Commentary on the Town Centre Improvements proposed by Babergh DC and SCC Highways

15 August 2022

Bus Station

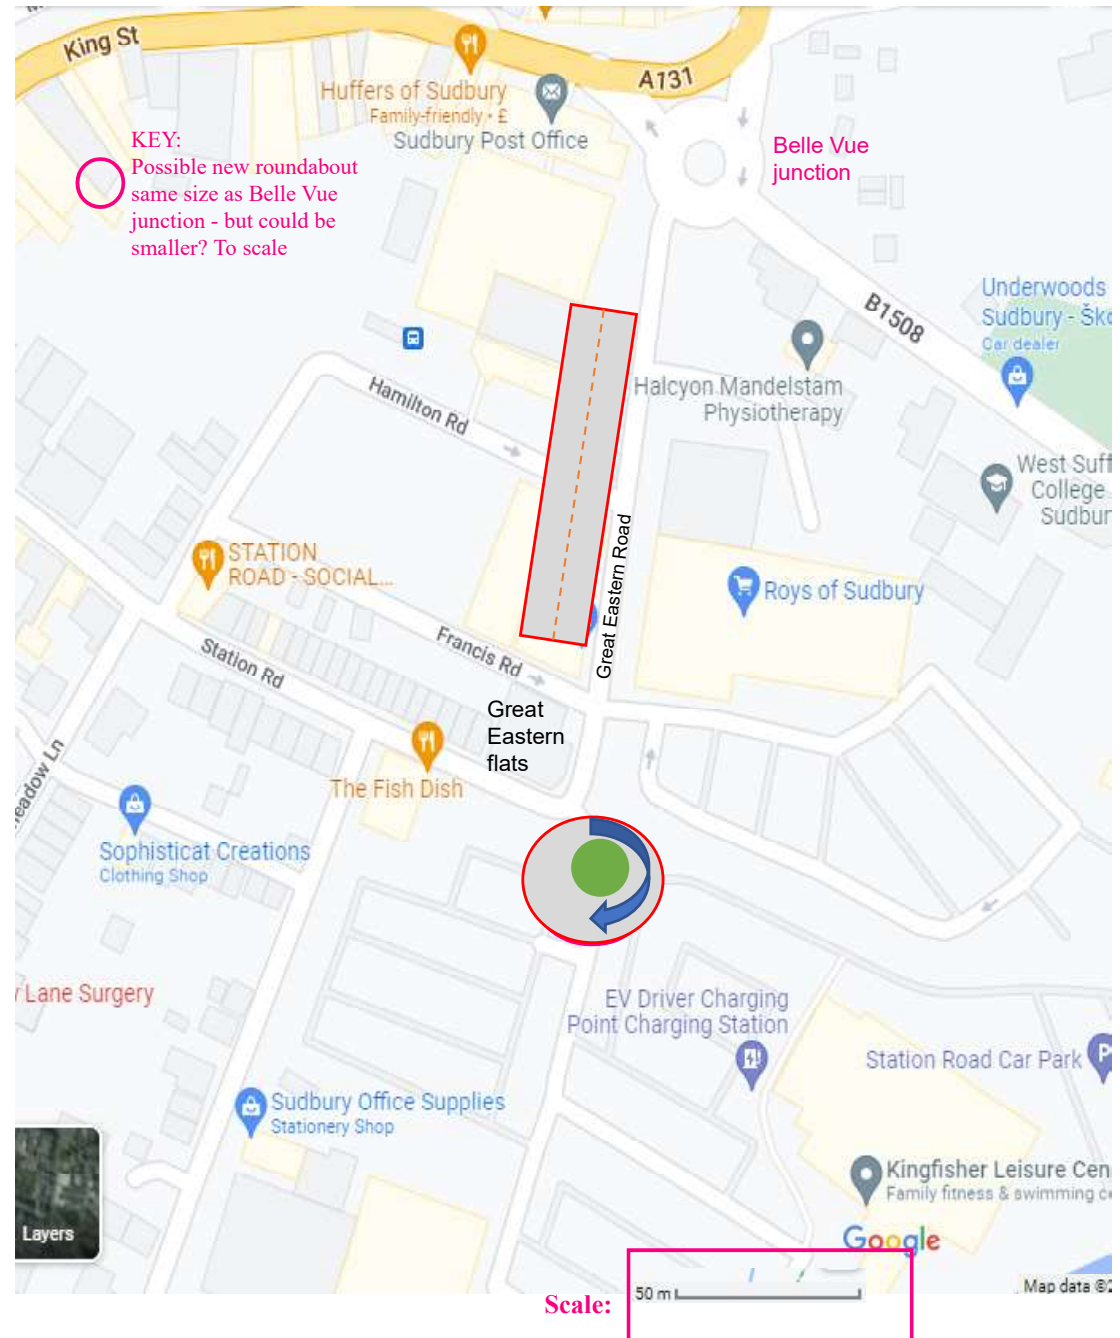
The bus station takes up far more space than is needed. We would be surprised if any more than 4 buses are there at any one time. But we believe that both visitors and towns-people need *a single point* from which buses depart. The dispersal of buses elsewhere simply will not work. If a 'bus hub' was established in Great Eastern Rd there would be no need for the bus or coach stops proposed for Market Hill.

In-bound buses can turn 180° at a new Waitrose/ Kingfisher roundabout, then drop/pick up passengers at a set of bays on the west side of Great Eastern Rd, widened by the removal of the Carpet Warehouse and other low-grade buildings.

Bus users would just get on/off their bus at this 'hub' and go on their way. Parking on Market Hill can be retained to the benefit of visitors and shops. Coaches, which are infrequent and run to no timetable, could be accommodated elsewhere, such as in Girling Street.

Great Eastern Street

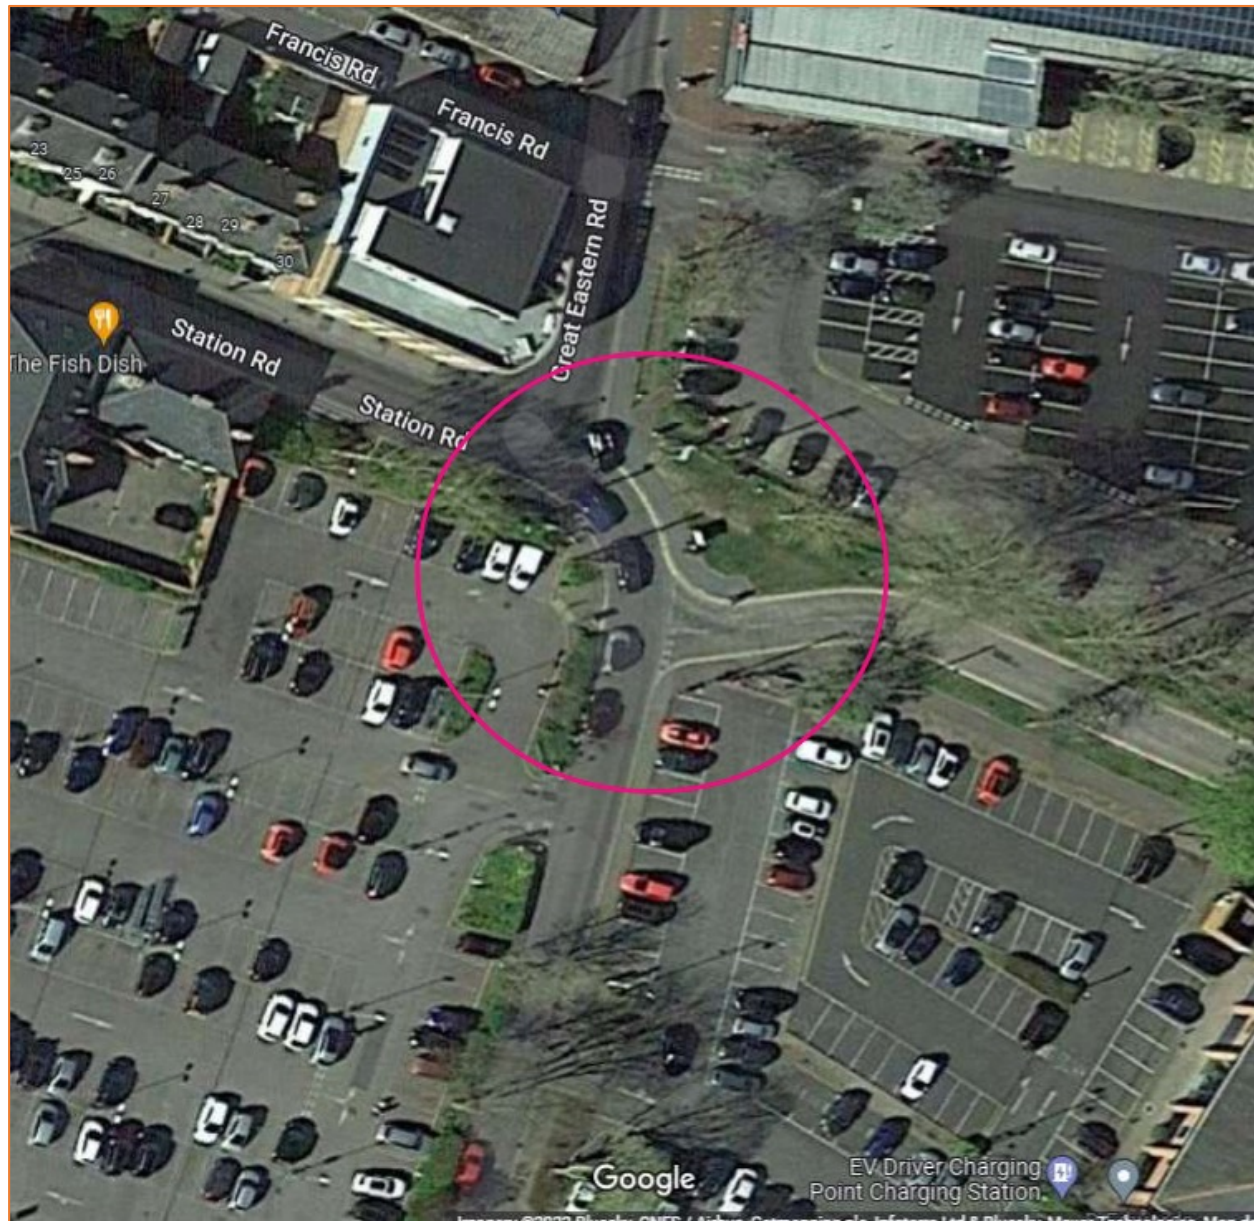
We estimate this roundabout would cause the loss of c. 20 parking spaces, a small fraction of the total nearby, and would mitigate traffic problems on this difficult corner.

It's essential for Station Road traffic to be able to reach Waitrose, the railway station, the Kingfisher and the new surgery complex *directly*.

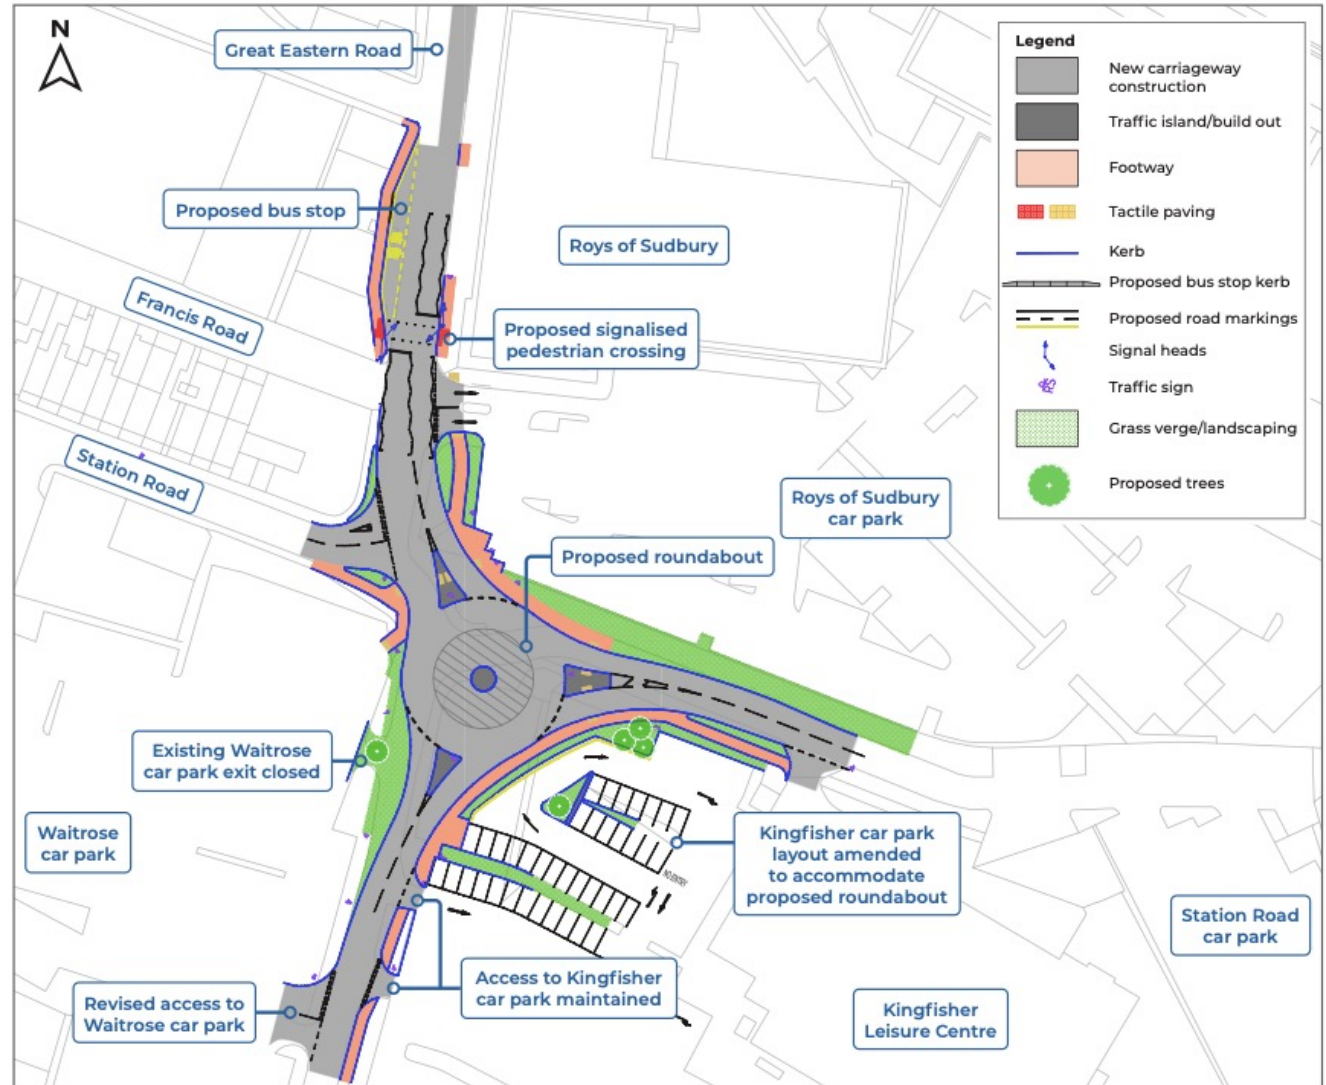
This proposal sends all such traffic up to the Belle Vue roundabout and back down again. We hope SCC Highways are not serious.

Ingrams Well Road

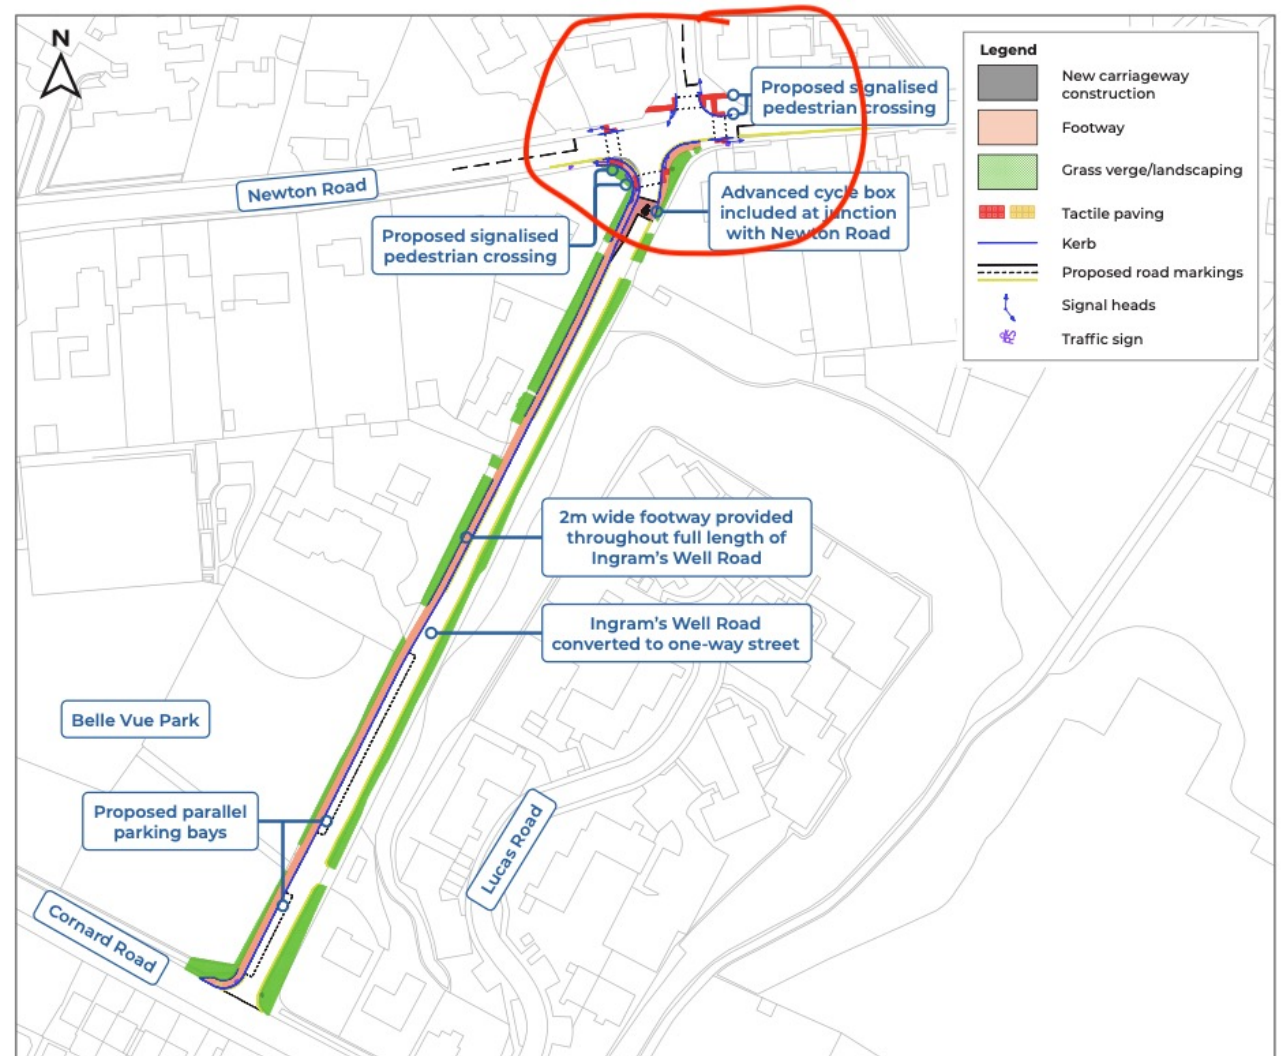
We see very little merit in this plan in proportion to the probable cost, which would be better spent elsewhere.

Why the conversion to a one-way street uphill. This will mean loss of parking in the road for park users or for those who work in Sudbury and avoid long-stay charges.

Pedestrian volume, which is very low, does not warrant any lights at the Newton Road Junction, let alone *two* pairs, which will add delays to the main route in and out of town to and from the south.

Granted, the exit from the road to Newton Road is tricky. One solution would be to cut back the grass bank to improve visibility.

Girlinging Street

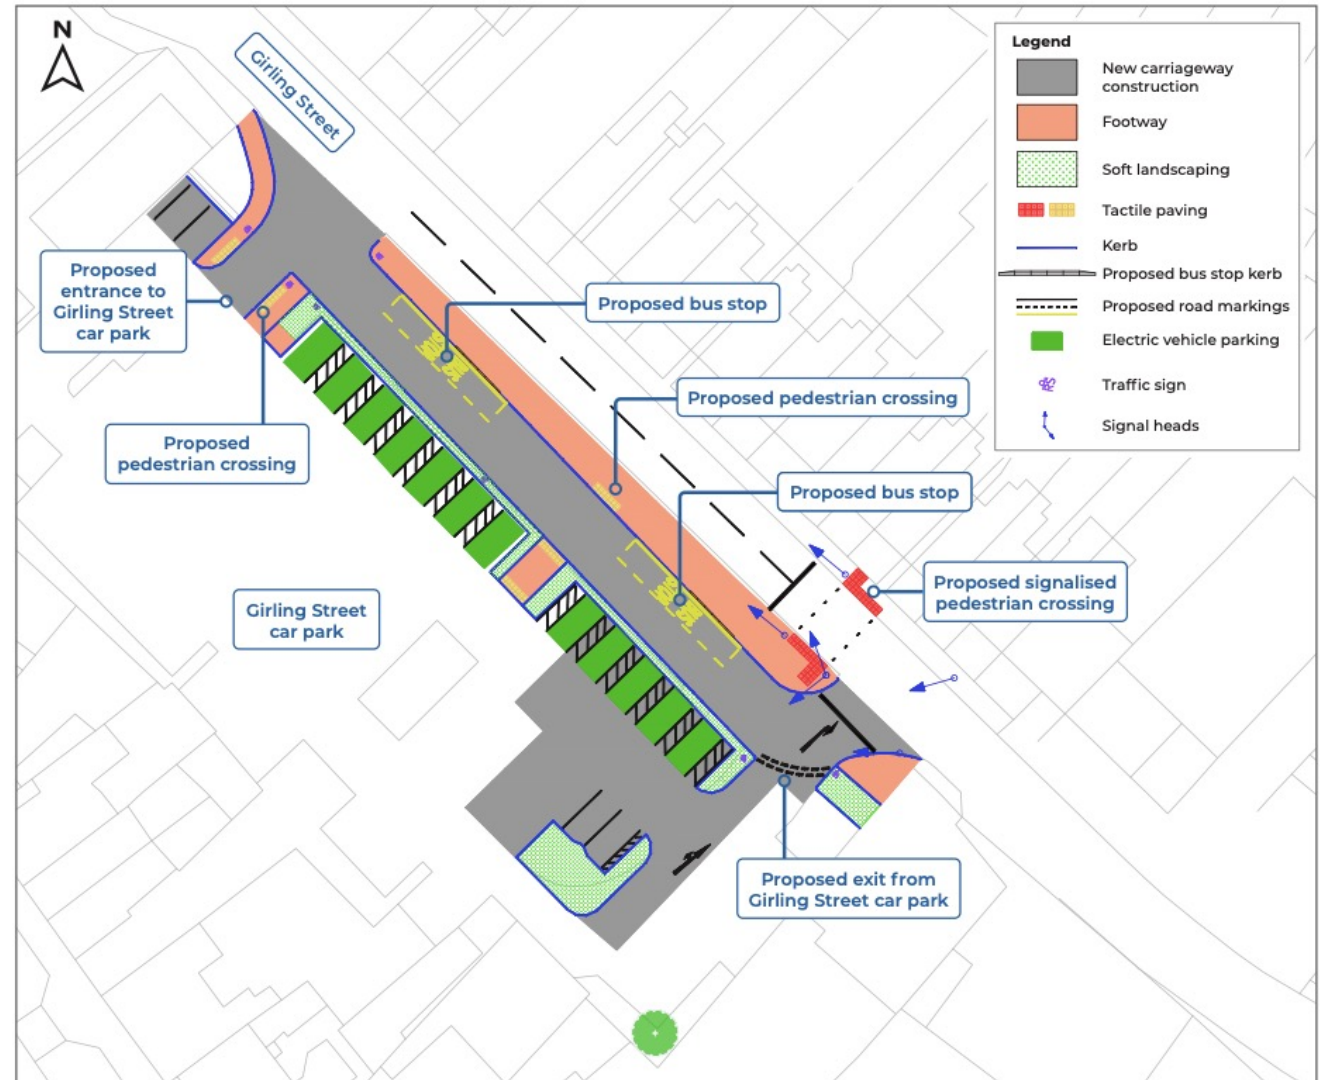
The proposals do not mention the loss of available parking spaces and this must be quantified. If the concept of a bus hub is feasible, no bus stops here will be necessary.

The pedestrian crossing specified here is completely unnecessary as it leads to nowhere significant and there are already two light-controlled crossings along the street nearby. Very few pedestrians can be seen using this footway. A third crossing will just add to congestion on what is supposed to be a through route for traffic.

The loading arrangements for Iceland and adjoining shops are ignored and, with cooperation between shop owners, a matter which causes regular congestion could be improved.

East Street

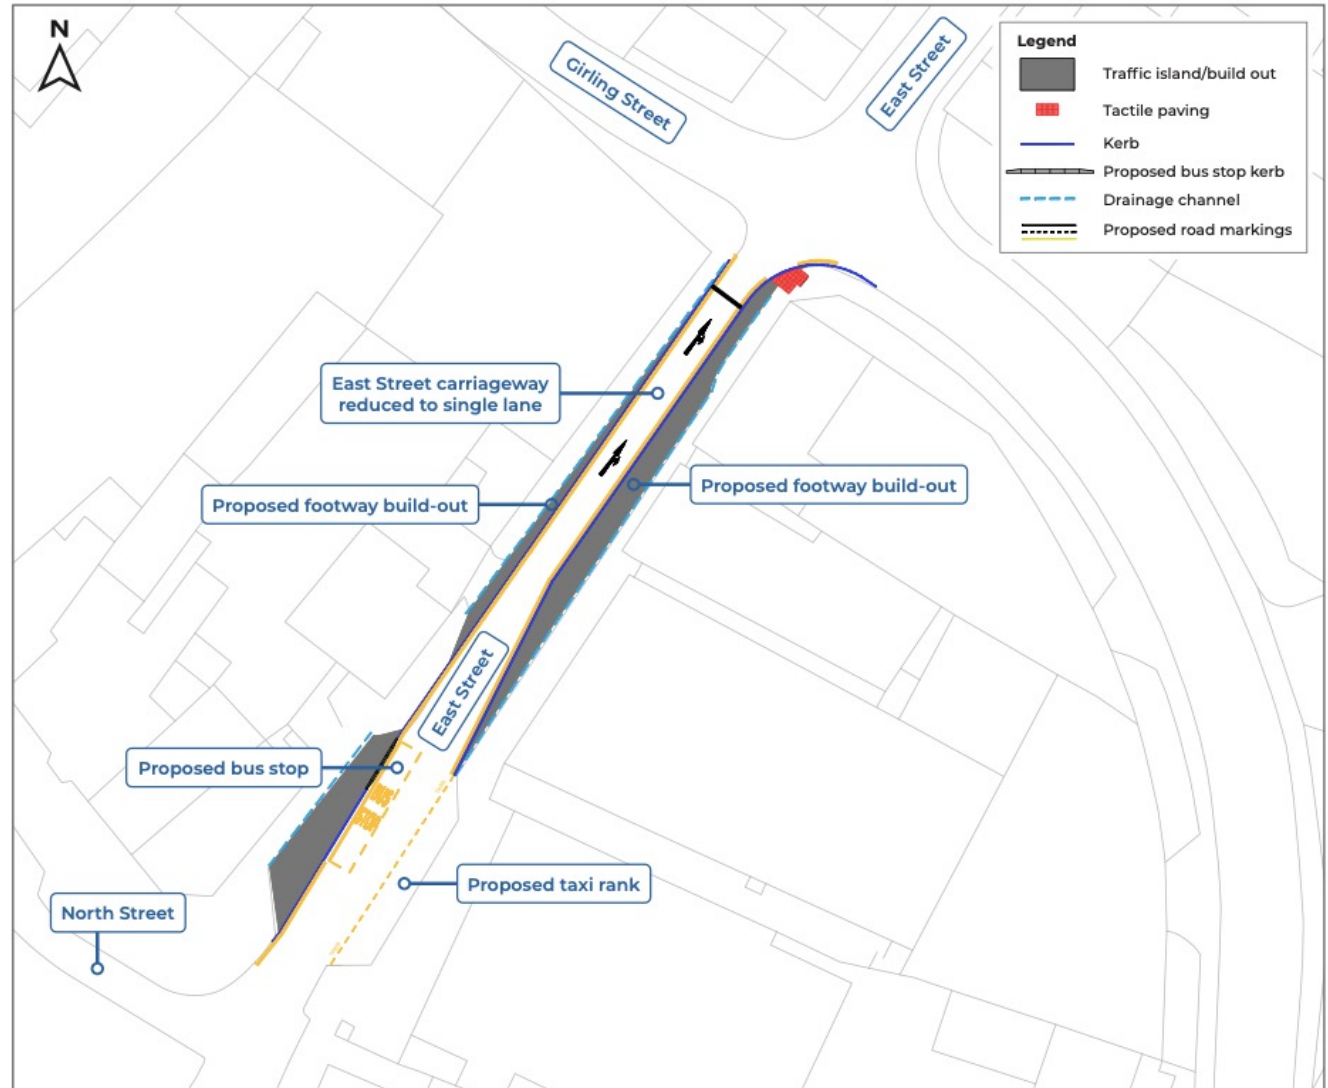
This proposal should be abandoned. The road is already very congested when deliveries take place with two lanes. And if it is reduced to a single track anyone wanting to turn right will cause traffic to back up. At present outgoing traffic can run at the same time as traffic coming in from out-of-town. This junction is one that will bear the brunt of increased flows from Chilton Woods.

We are told that it has to become single lane to allow buses to turn right into Girling Street. This is an infrequent event and a bus can do this already simply by straddling both lanes as they approach the lights.

Broadening the south side pavement is also pointless. Few people walk along this side of the street – they mostly use the north side to make use of the light-controlled crossing.

Market Hill, planting

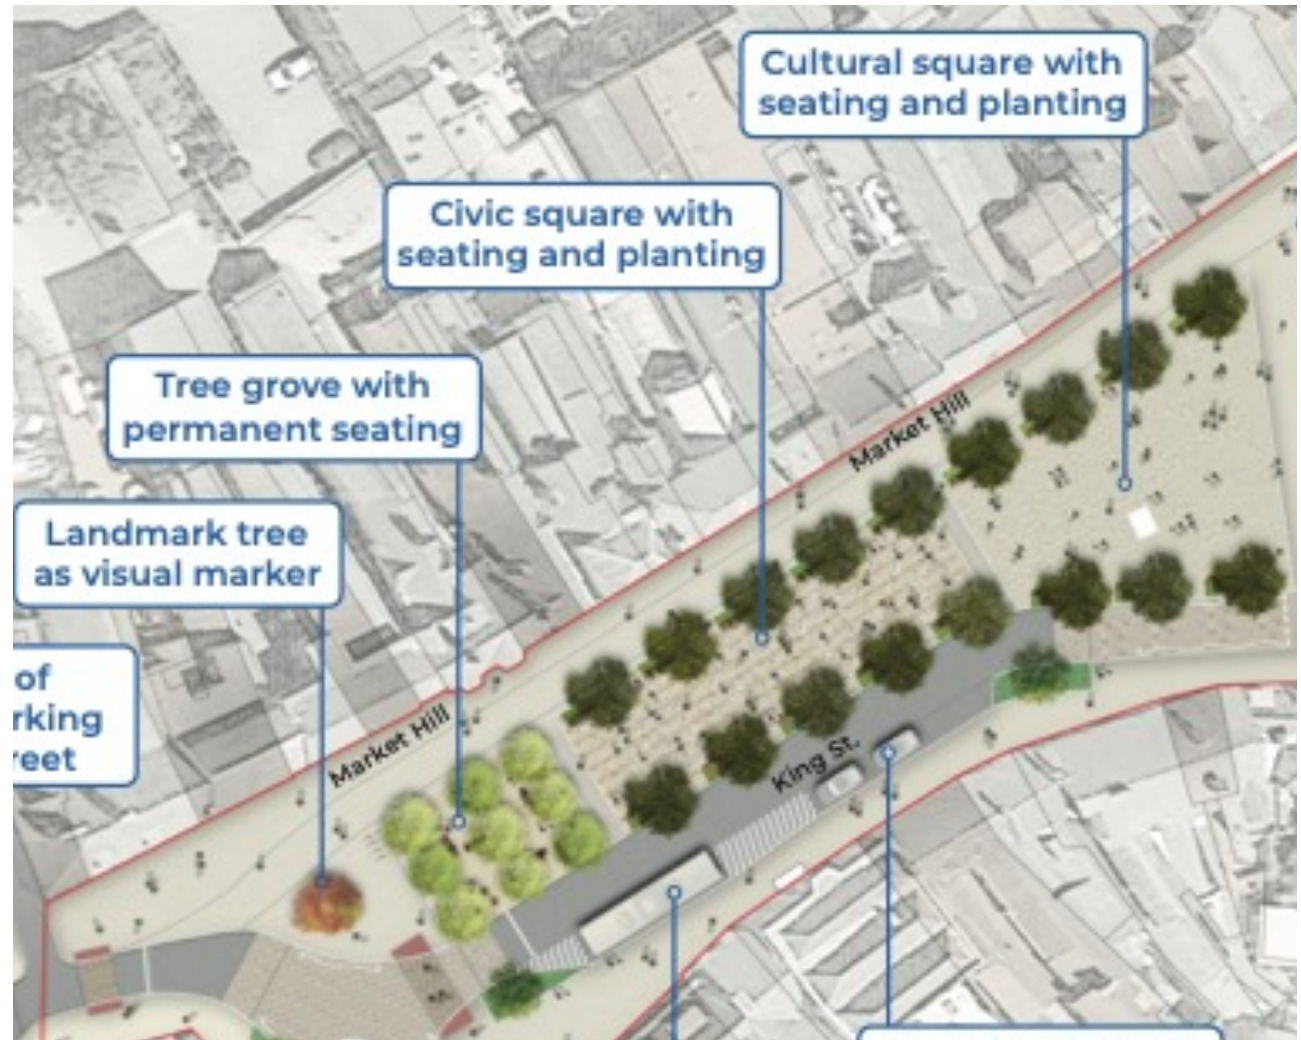
Any more trees of any kind should on no account be planted on Market Hill, especially not 'landmark' trees, which will block views of St Peter's and change the character of this central space.

If planted in the ground their roots will affect the reportedly complex network of underground services here.

If planted in tubs they will need after-care, watering, pruning and weeding. In either case they will generate a great deal of leaf clearance and we doubt such council services will be available at the standard of care required.

Please just forget this element of the plans. Any new planting can be confined to the 'high hedge' proposed on the following slide.
